ASSESSMENT REPORT

Section 75W Modification Riveroaks Residential Subdivision, Ballina Local Government Area MP 06_0118 MOD 2

Figure 3: Proposed Subdivision Layout

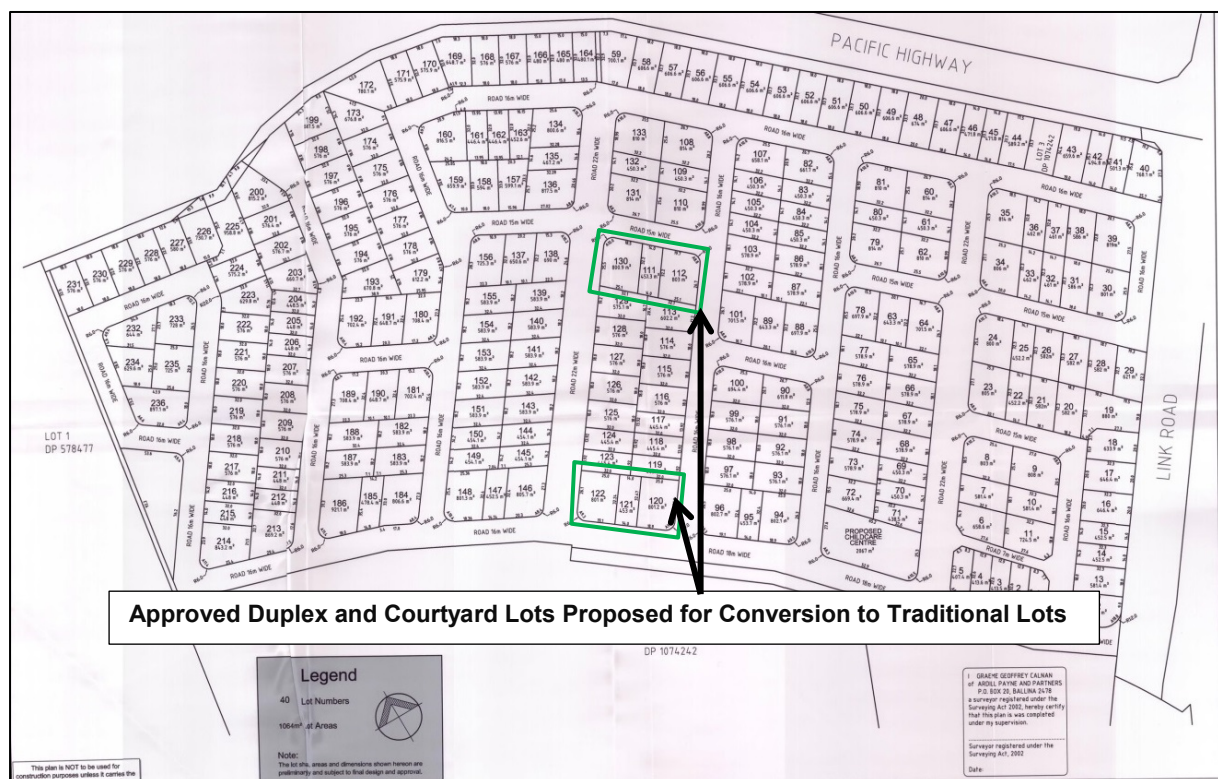
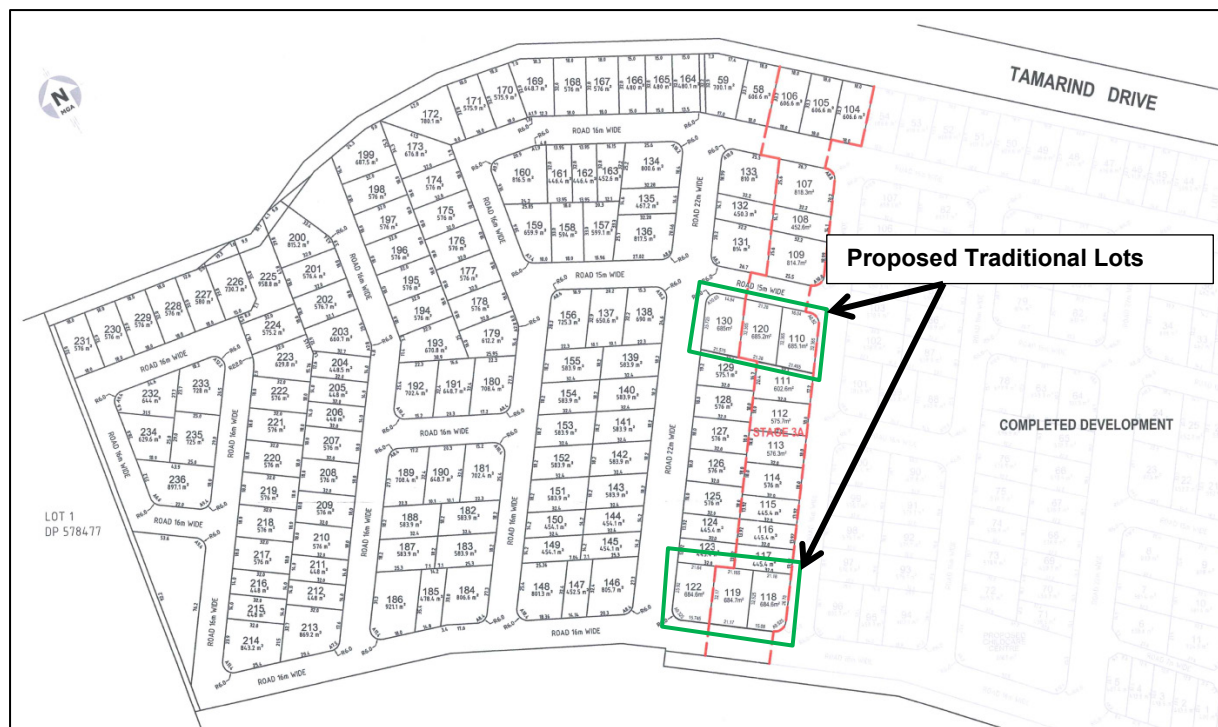
On 24 March 2015, the Proponent lodged a section 75W modification request (MP06_0118 MOD 2) seeking approval to:

- convert four duplex and two courtyard lots to six traditional residential lots (lots 111, 112, 120, 121, 122, and 130);
- amend the staging description in Condition A2;
- revise the lot numbering in Stage 3A; and
- amend conditions B8 (2) and D3 (7) and Statement of Commitment 16 to reflect the revised lot numbers.

- respond to an increase in demand for larger (500 m² to 700 m²) residential allotments;
- comply with LPI lot numbering requirements to facilitate the registration of future plans of subdivision; and
- reflect the proposed changes to the lot configuration and numbers in the conditions of the Project Approval.

The Department notes that there is no change to the number of approved lots, and there will be no additional environmental impacts beyond those assessed under the original Project Application as a result of the proposed modifications.

Figure 4: Approved (Left) and Proposed (Right) Layout of Lots

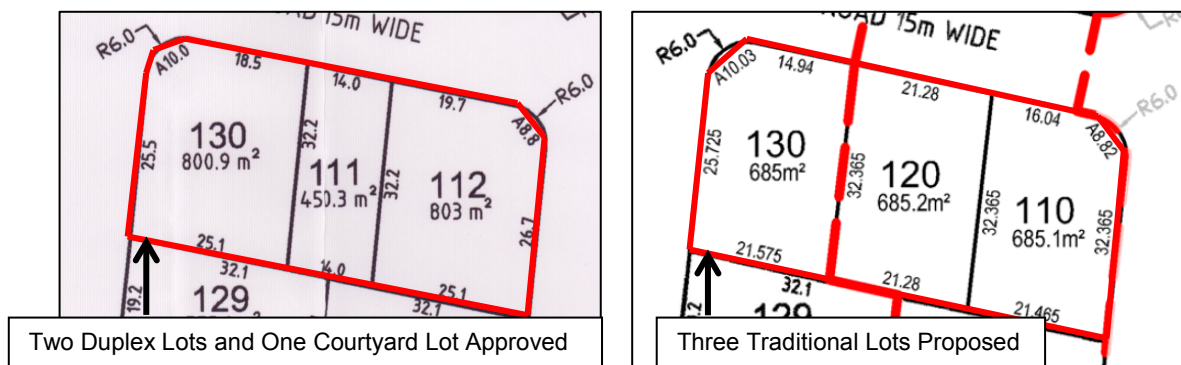
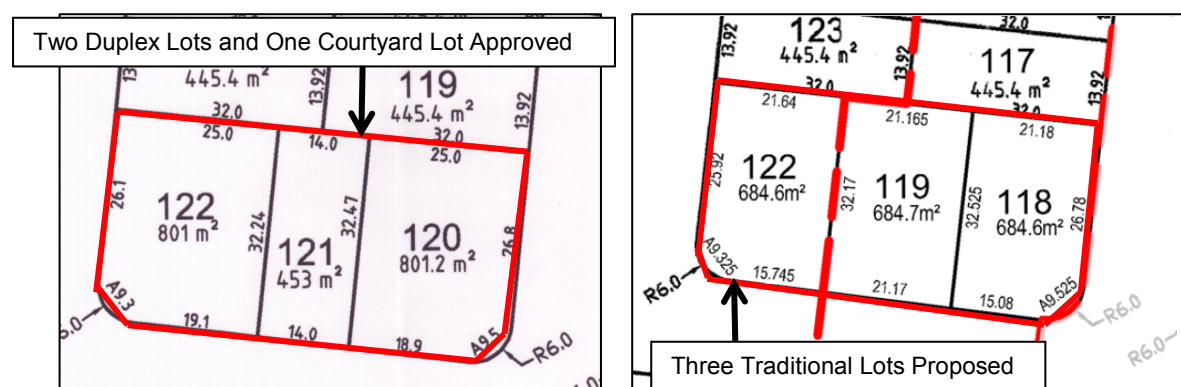
The request seeks approval to reconfigure lots 130, 111, 112, 122, 121 and 120 to replace four duplex lots and two courtyard lots with six traditional allotments. The proposed modifications are depicted in **Figures 4** and **5** below.

The Proponent has advised that the proposed modifications to the subdivision layout are required to respond to a drop in the demand for duplex and courtyard allotments. **Table 1** below provides a comparison of the approved and proposed lot sizes and types the subject of the modification request.

Approved Lot No	Approved Size	Approved Lot Type	New Lot No	Proposed Size	Proposed Lot Type
111	450.3 m ²	Courtyard	120	685.7 m ²	Traditional
112	803 m ²	Duplex	110	685.1 m ²	Traditional
120	801.2 m ²	Duplex	118	684.6 m ²	Traditional
121	453 m ²	Courtyard	119	684.7 m ²	Traditional
122	801 m ²	Duplex	122	684.6 m ²	Traditional
130	800.9 m ²	Duplex	130	685 m ²	Traditional

The Department has reviewed the revised lot layout and has concluded that the proposed lot sizes will not result in any additional environmental impacts beyond those assessed under the original Project Application, and will continue to provide a high level of residential amenity. In addition, the Department is satisfied that the subdivision will continue to provide an appropriate range of lot size and types to provide a diversity in housing choices within the locality. Accordingly, the Department supports the revised subdivision layout.

Figure 6: Comparison of Lots Requiring the Registration of a Restrictive Covenant to Regulate the Provision of On-Street Car Parking (Approved Left, Proposed Right)

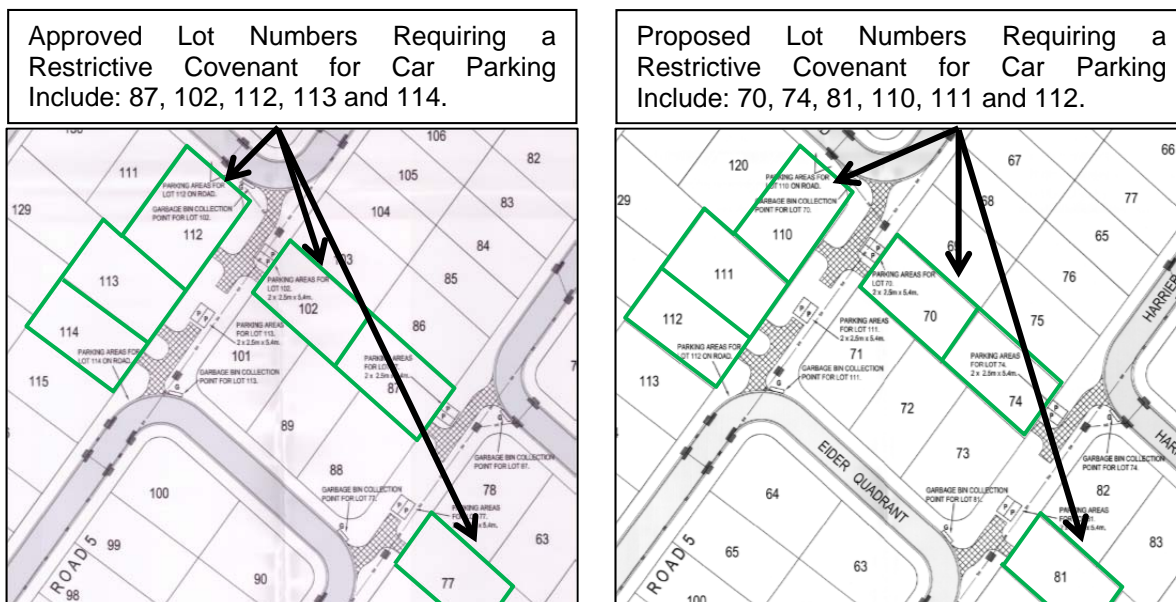
As previously outlined, the application seeks approval to revise the lot numbers within Stage 3A to ensure compliance with the LPI's lot numbering requirements to enable the registration of future plans of subdivision. In this regard, the proposed revisions to the approved lot numbers will require amendments to conditions A2, B8 (2) and D3 (7), and SOC 16 to:

- identify the lots requiring the provision of on-street car parking and associated turning bays; and
- identify the lots that require the registration of restrictive covenants advising future land owners that their dwellings must be set back a minimum of 1 m from the property boundary.

The Department has reviewed the proposed modifications to the conditions of approval and considers that the revisions to conditions A (2) and B8 (2) and SOC 16 are administrative in nature on the basis that they are only required to reflect the proposed increase in the number of traditional allotments and the changes to the approved lot numbers proposed in the revised Plan of Subdivision. In addition, the Department has concluded that:

Figure 7: Comparison of Lots Requiring the Registration of a Restrictive Covenant to Regulate Dwelling Setbacks (Approved Left, Proposed Right)

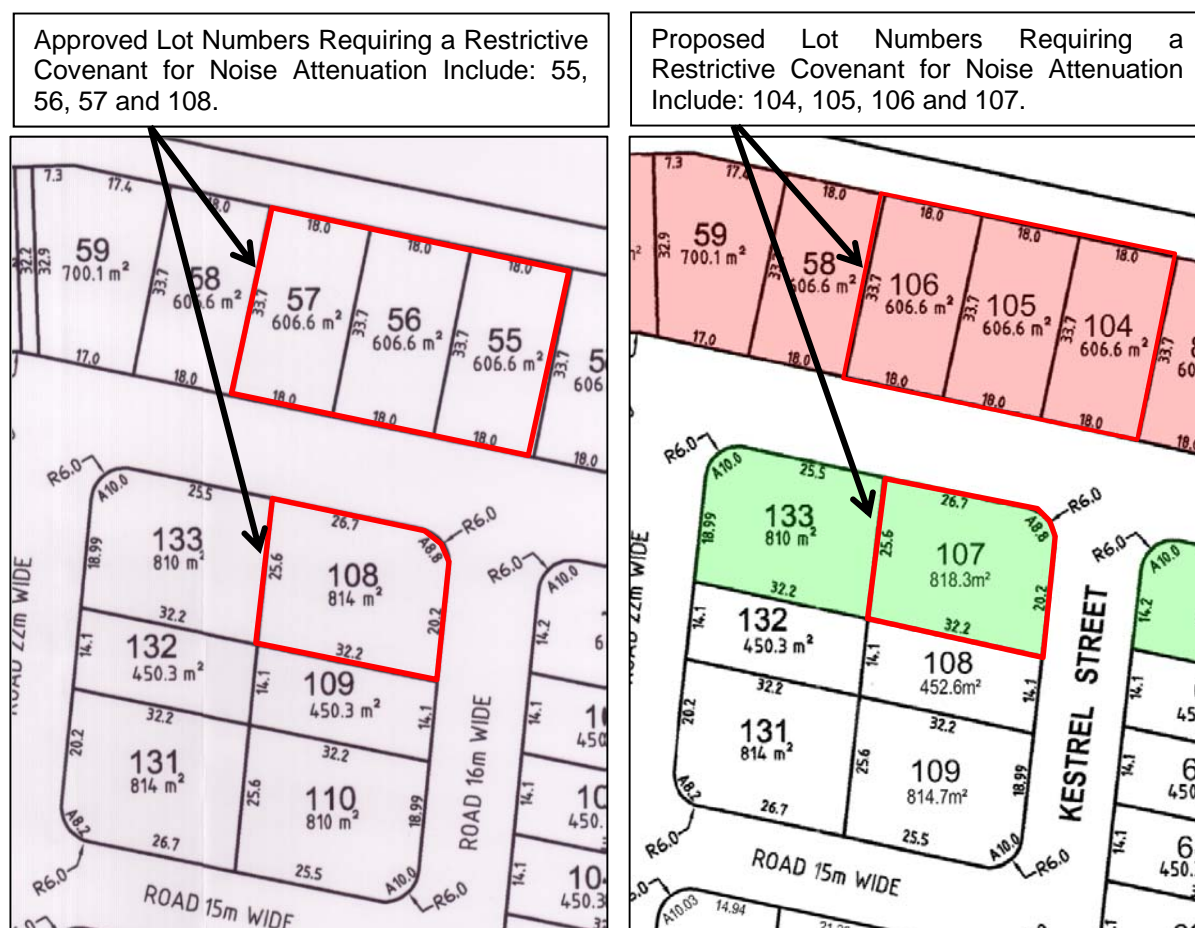
- Condition D3 requires additional amendments beyond those proposed by the Proponent to ensure that requirements (5) and (6) are updated to reflect the proposed modifications to the approved lot numbers; and
- Condition D3 (7) is no longer required on the basis that the *Ballina Development Control Plan 2012* (DCP) specifies appropriate boundary setbacks for residential dwellings on small lots (lots under 480 m²).

- Condition A(2) is amended to reflect the proposed increase in the number of traditional allotments; and
- Condition D3 is amended to delete requirement (7), and update requirements (5) and (6) to reflect the proposed modifications to the approved lot numbers.
